ADDENDUM #2 – APRIL 2, 2025

RE: CITY OF COQUILLE URA
N. Adams Street Improvements Phase 1: Underground Improvements
Project #23.81

FROM: HGE ARCHITECTS, Inc.
333 South 4th Street
Coos Bay, Oregon 97420
541-269-1166

SHEET TITLE: WATERLINE IMPROVEMENTS - STA 50+00 - 55+00

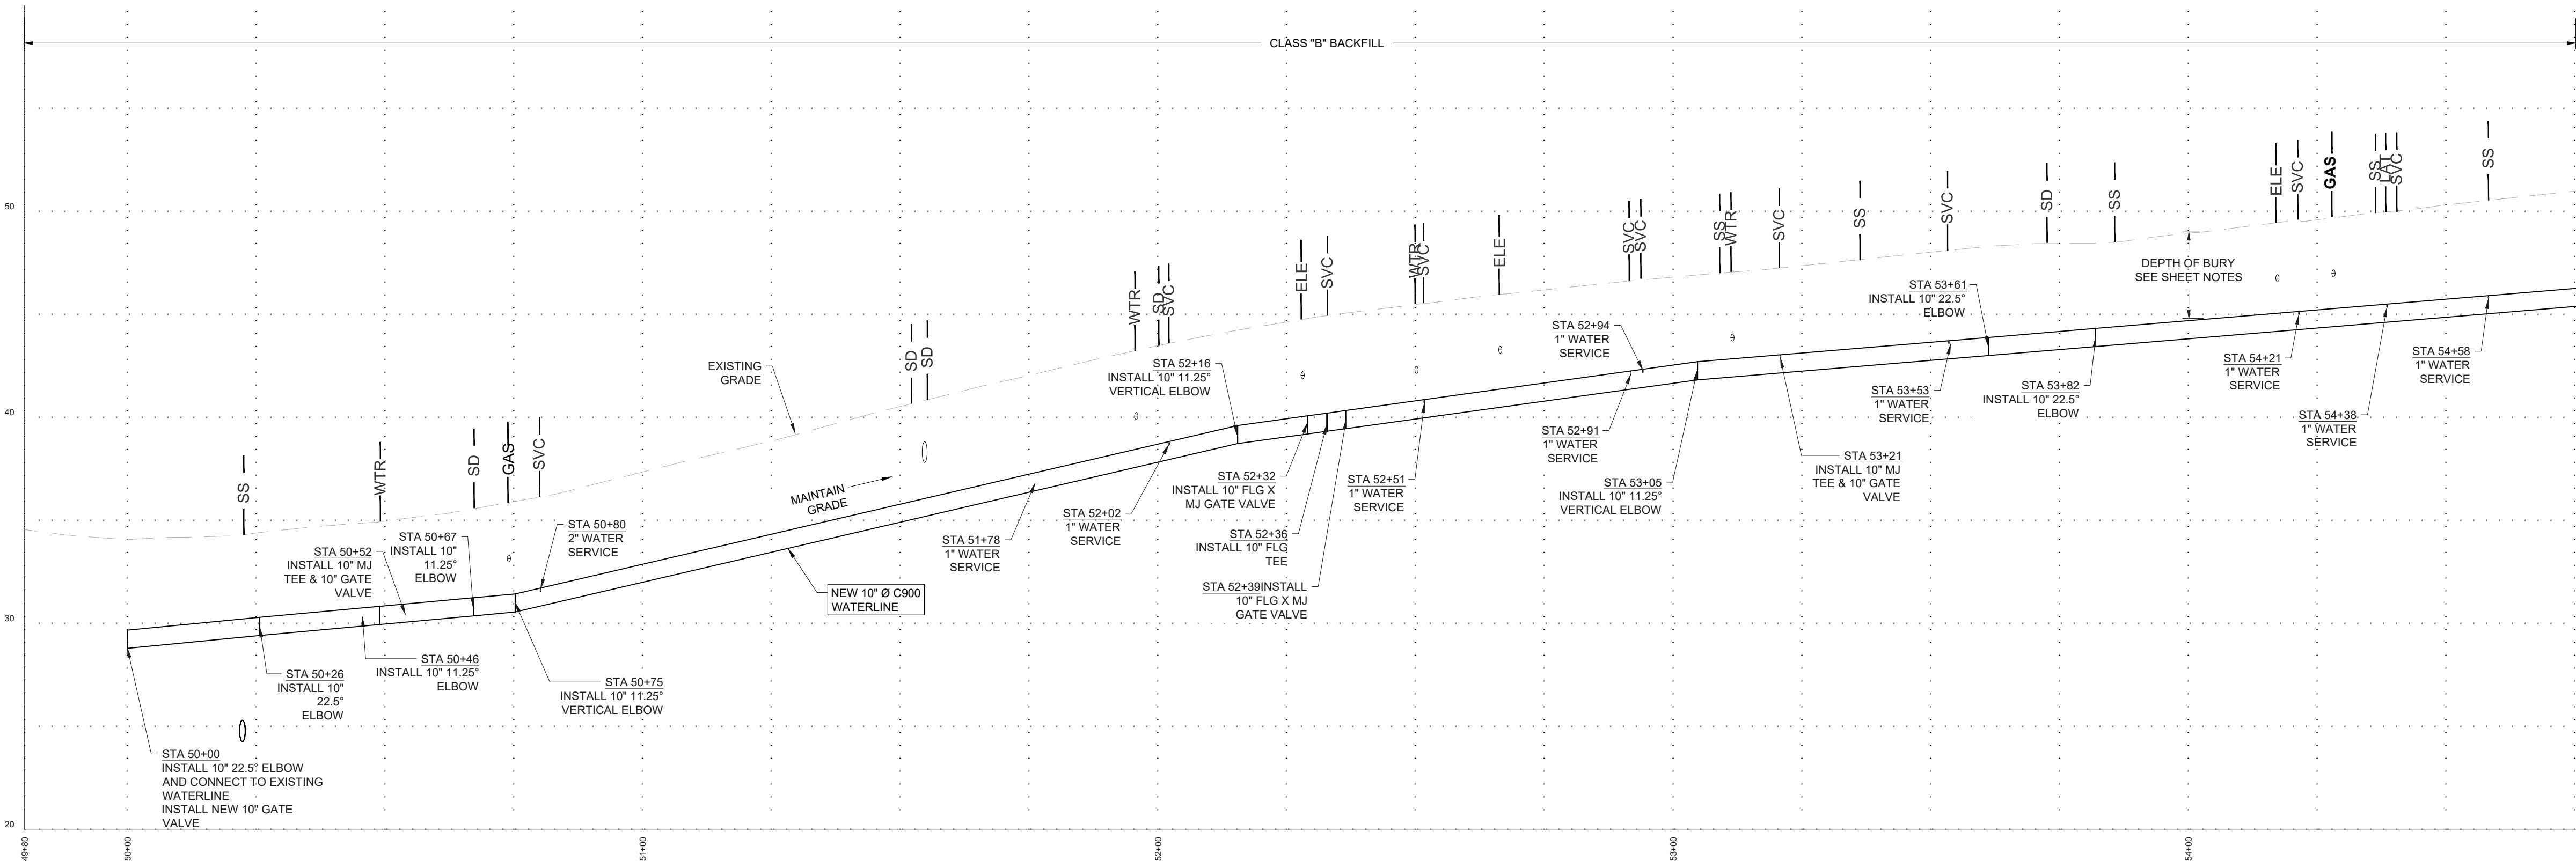
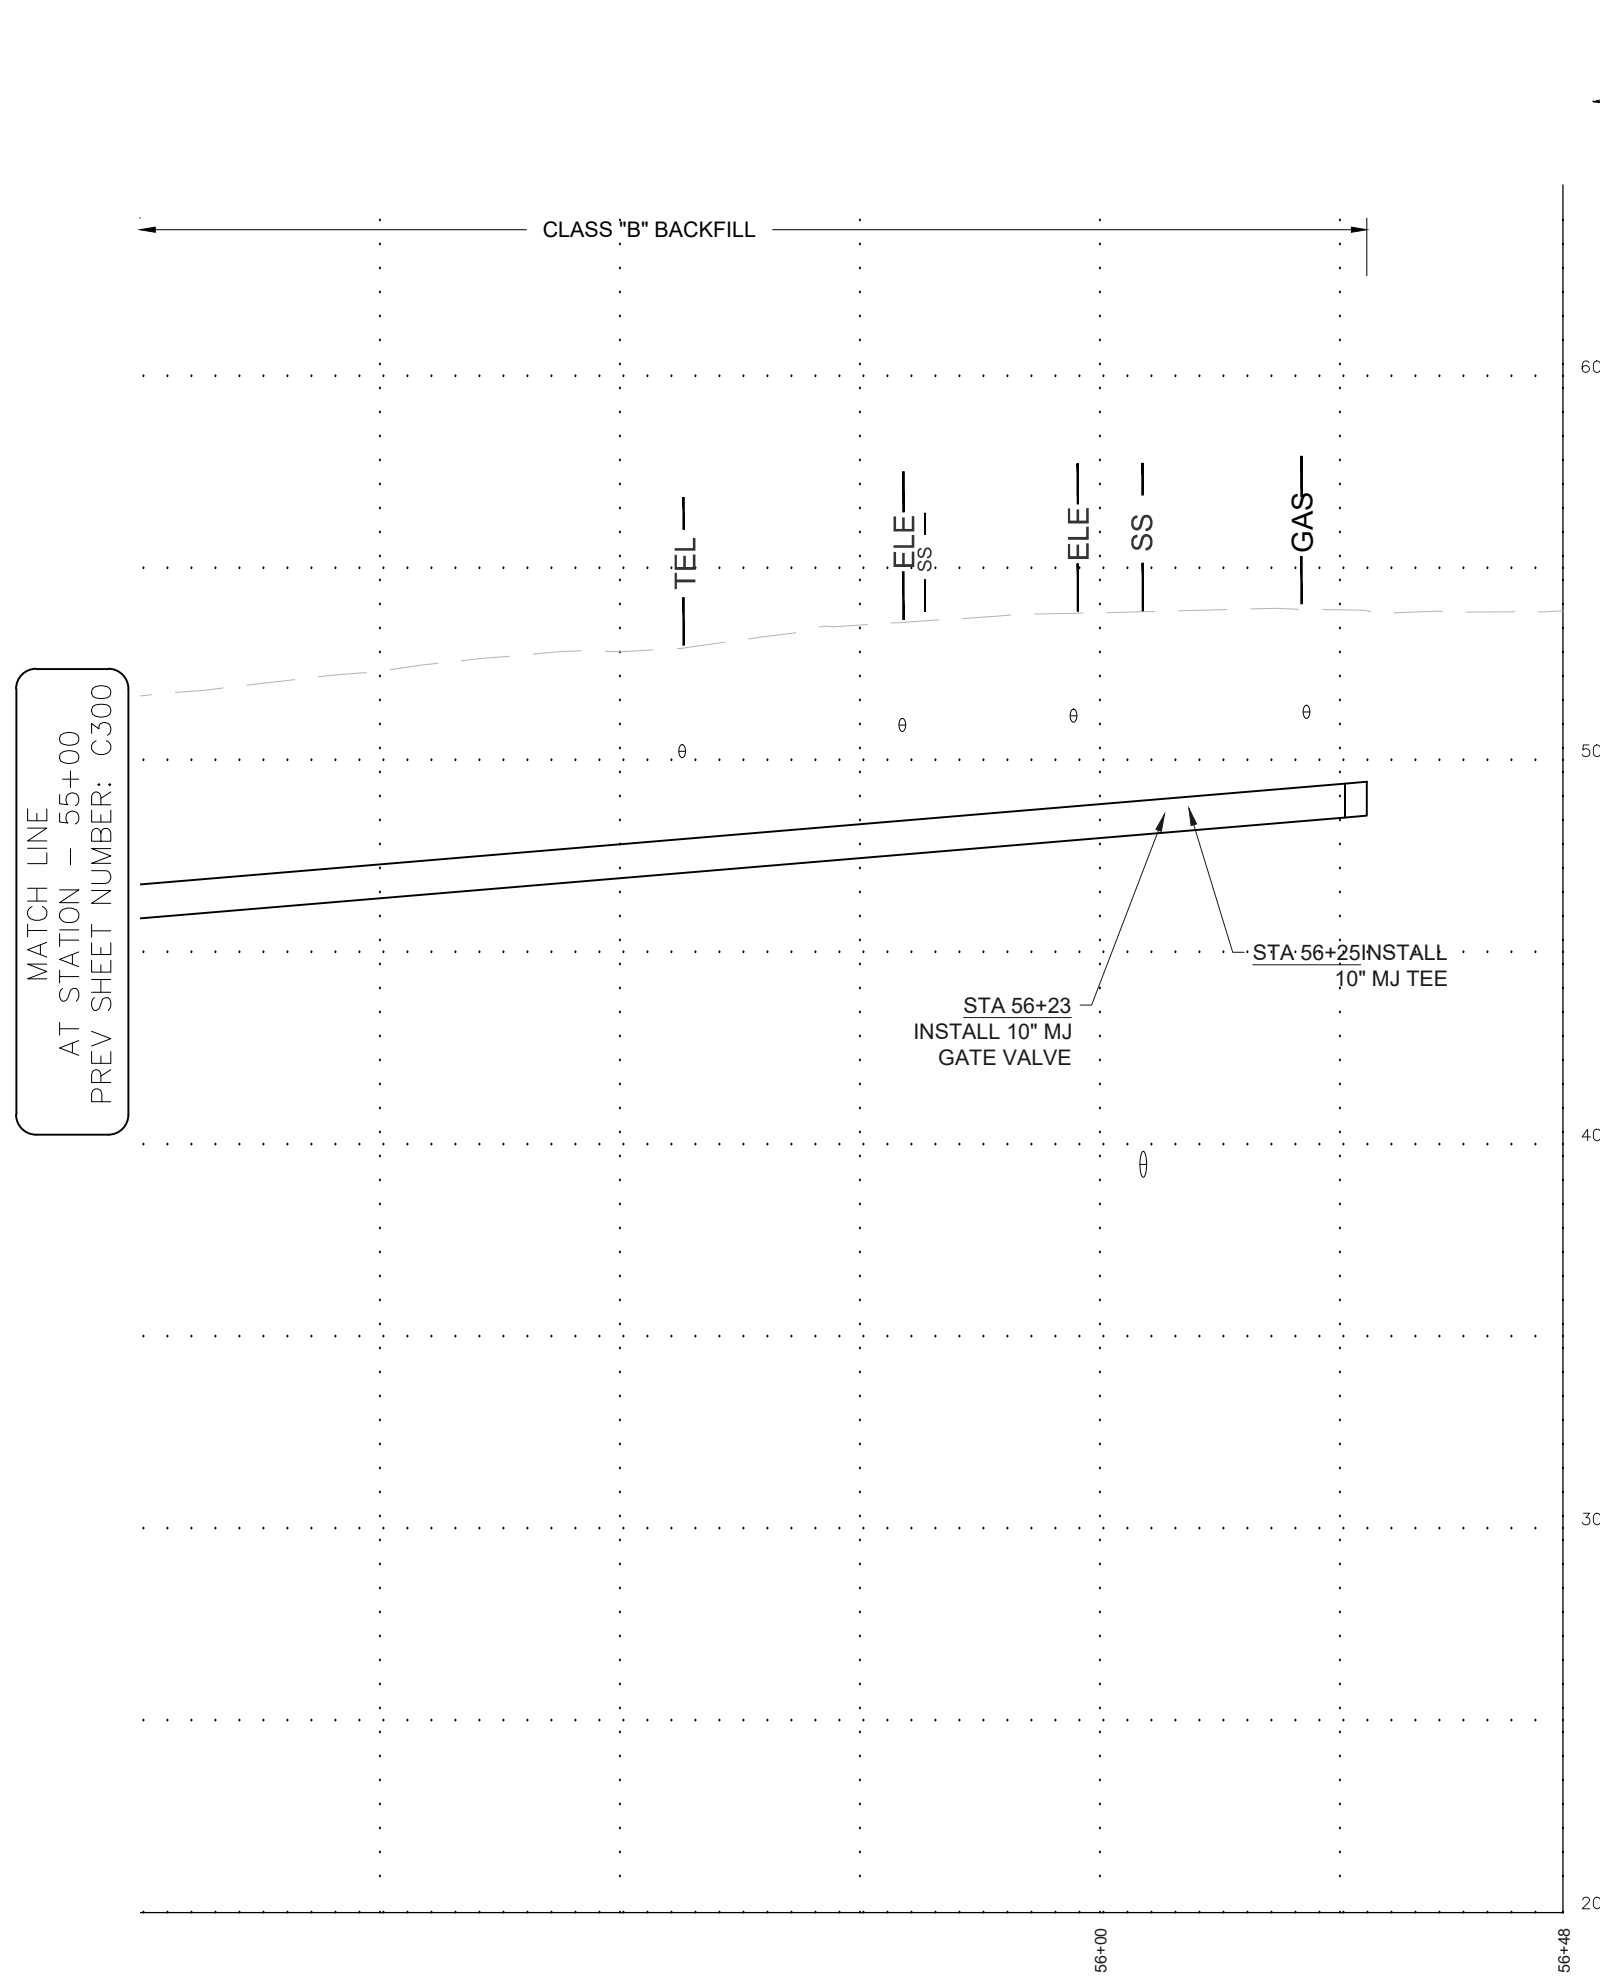
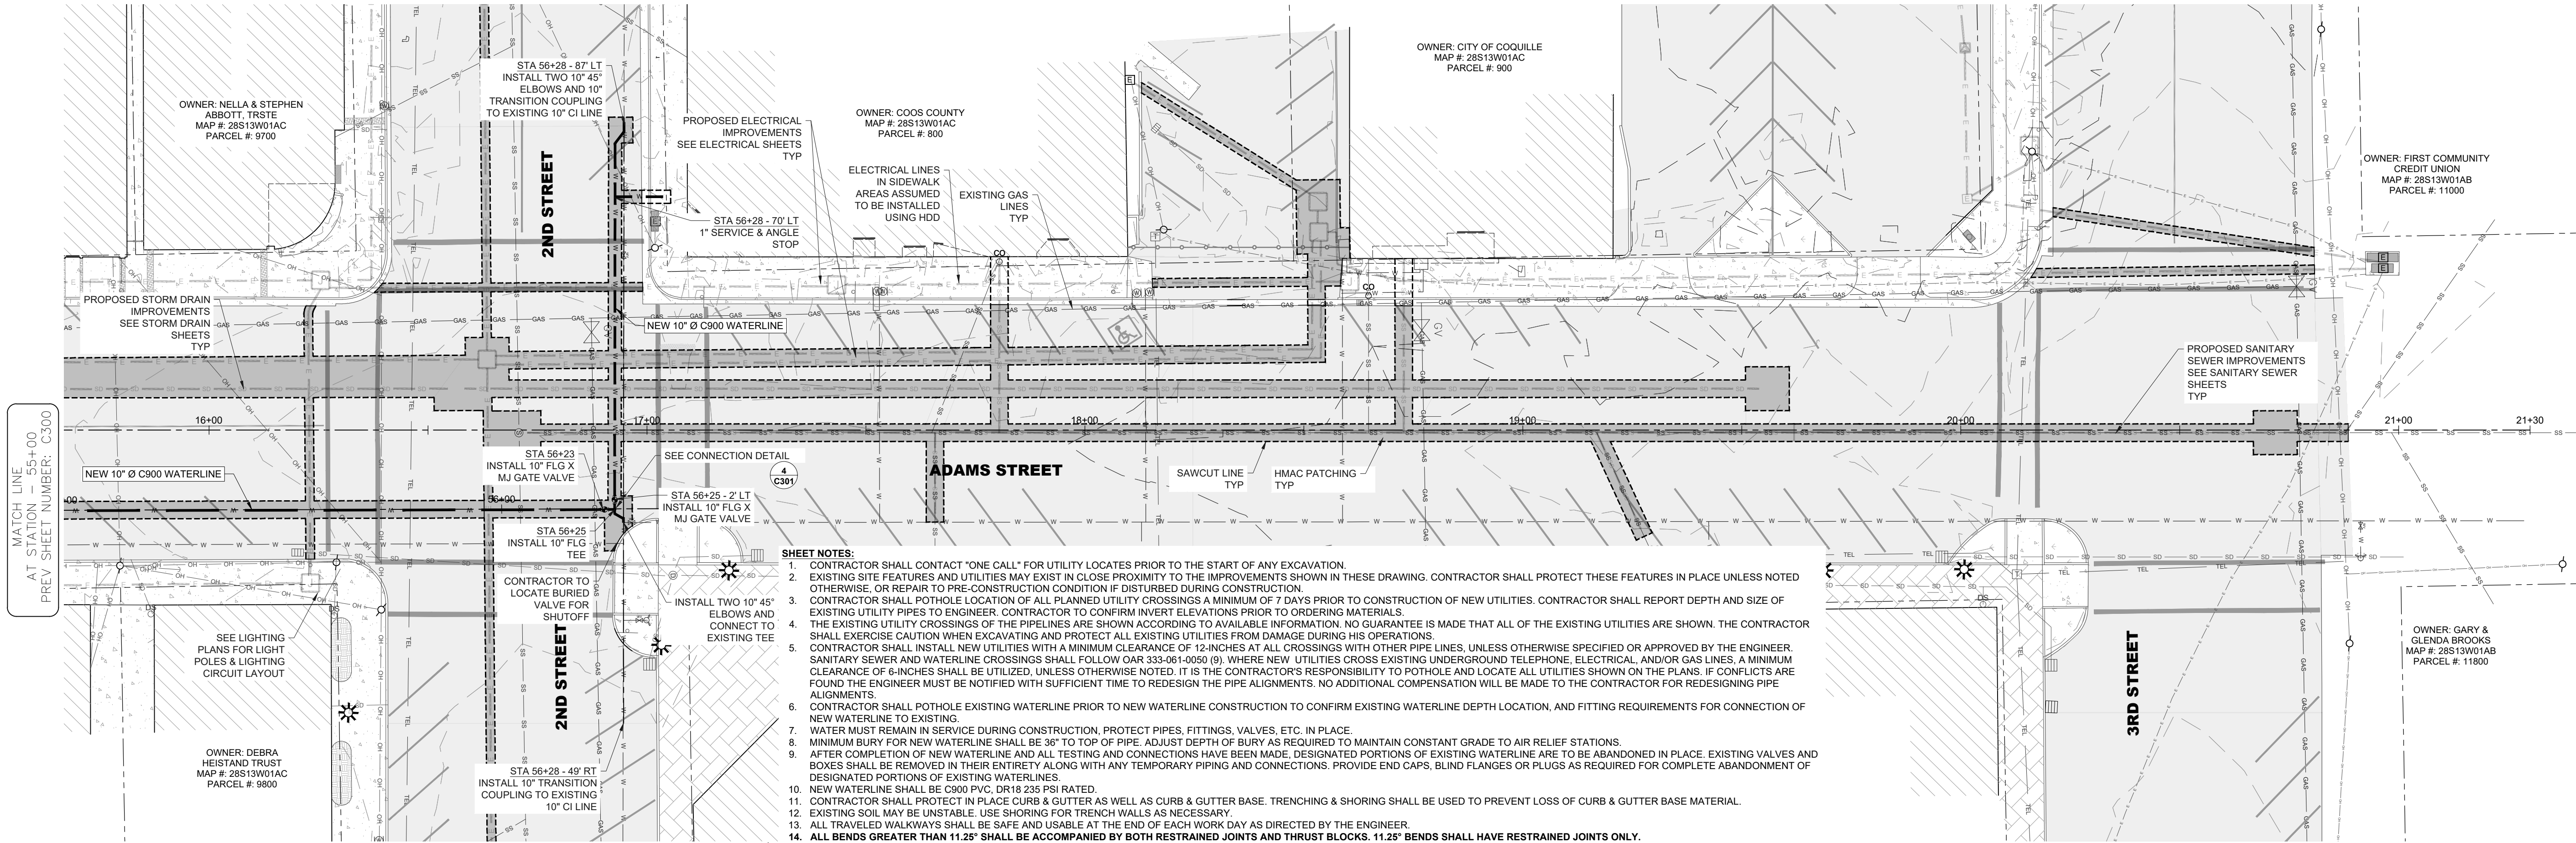
- a. **Revision Summary:**
 - i. Added lateral at 40+95, corrected 42+09 to 6" from 4"
 - ii. show point of connection for lateral at FCCU.
3. **Sheet C300 Waterline Improvements – STA 50+00 – 55+00:** REPLACE sheet with attached revised sheet.

- a. **Revision Summary:**
 - i. Added gate valve for 2" service to Nosler
 - ii. Corrected services to Sawdust Theater to 4" fire line and 2" domestic
 - iii. Switched some tees to flange, using flg x mj gate valves for simplicity (as opposed to mj tees to mj valves)

SHEET TITLE:
WATERLINE
IMPROVEMENTS - STA
55+00 - END

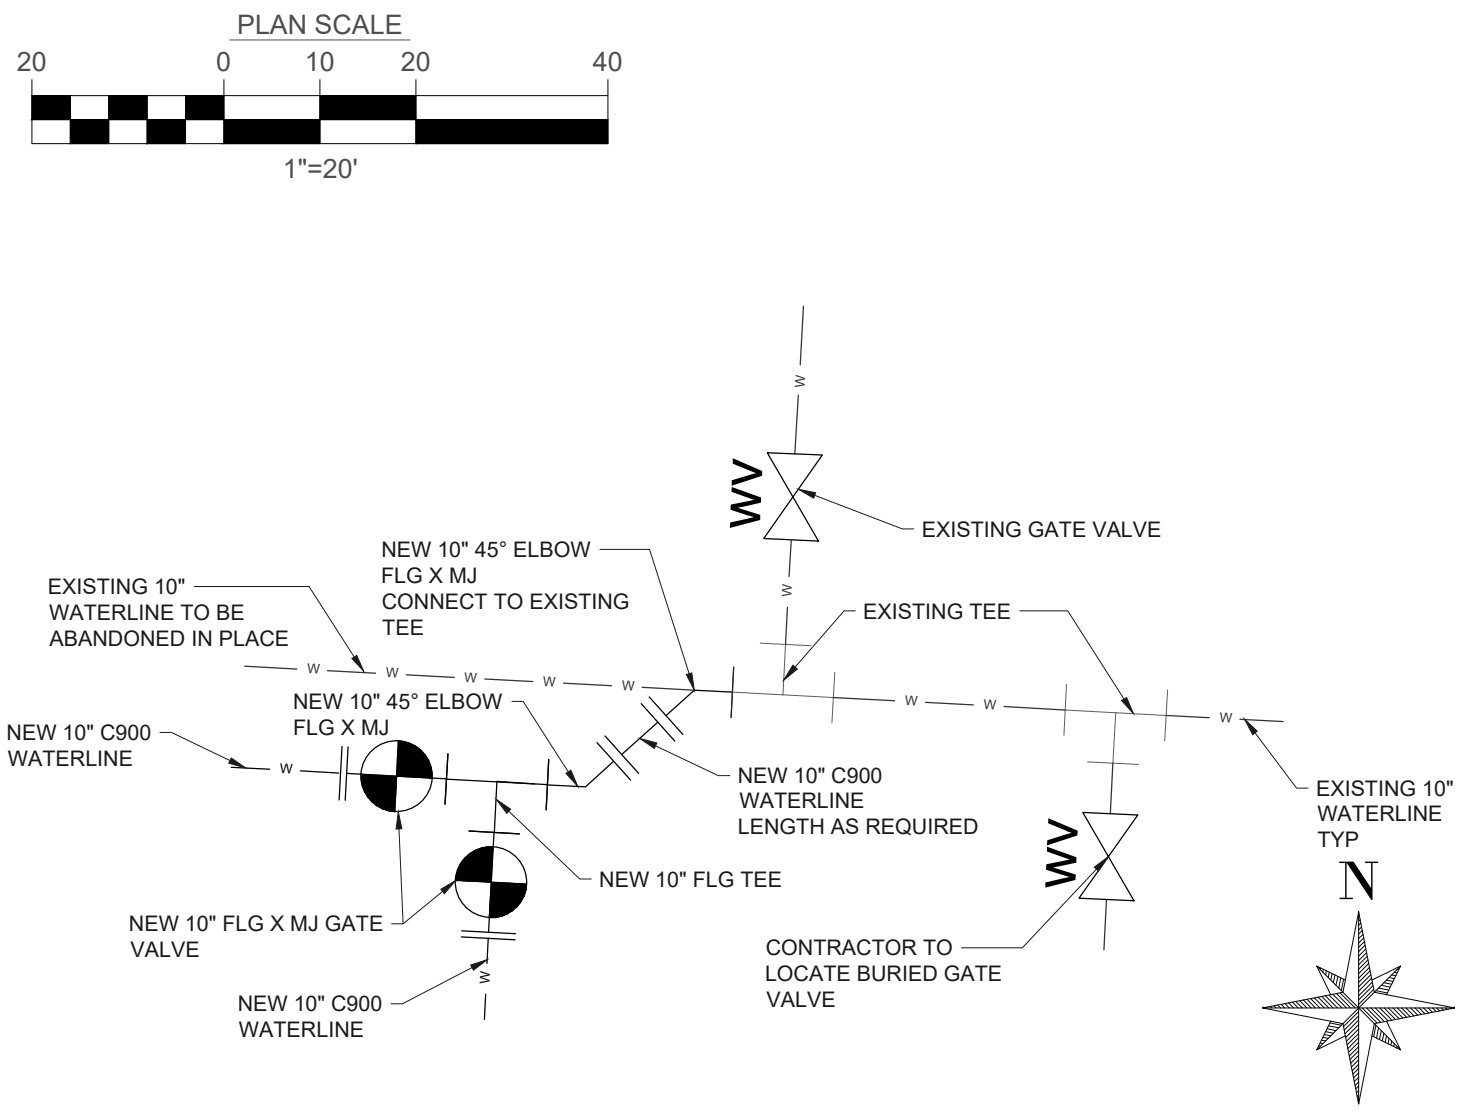
4. **Sheet C301 Waterline Improvements – STA 55+00 - END:** REPLACE sheet with attached revised sheet.
 - a. **Revision Summary:**
 - i. Added note to find buried valve

- ii. Added waterline connection details
 - iii. Switched some tees to flange, using flg x mj gate valves for simplicity (as opposed to mj tees to mj valves)
